NON-COMPLIANCE REPORT # 33413-39, 33413-110 & 33415-9

PART NAME: KINEMATIC VEE SUPPORT
 PF/SA NO.: PF-382-909-47 R0
 WORK ORDER NO.: 33413-39, 33413-110 & 33415-9
 VENDOR: GIVMAR

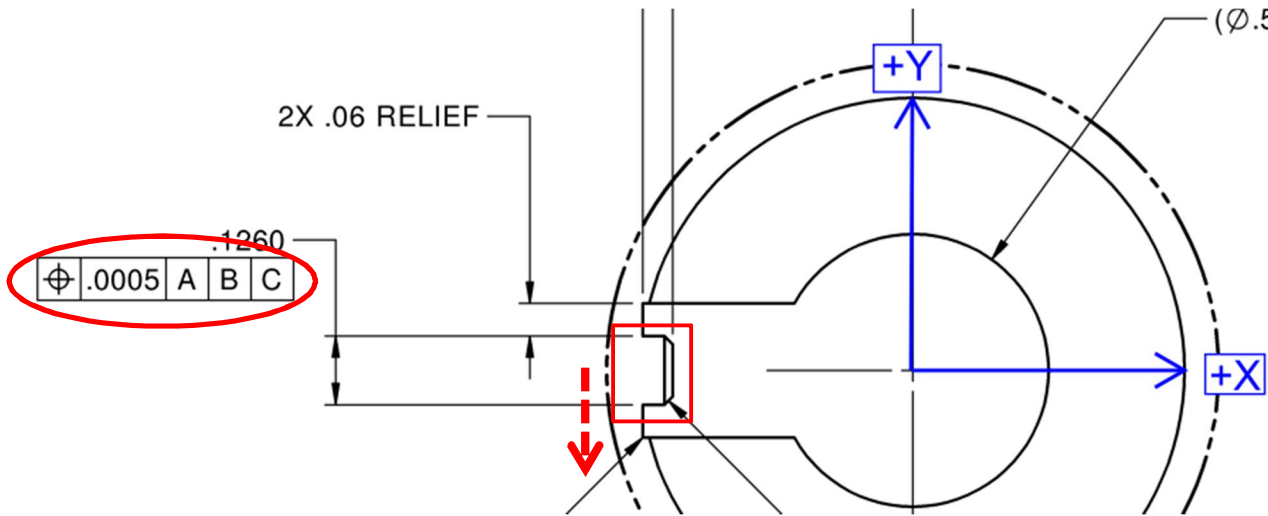
1. $\varnothing .0005$ A B C OF **.1260** (DETAIL B) is out of position on all 12 parts ranging from 0.0036 - 0.0079".
 - a. Y symmetry of .1260 measures between -0.0018 to -0.0039 (all on the -Y direction).

UAI
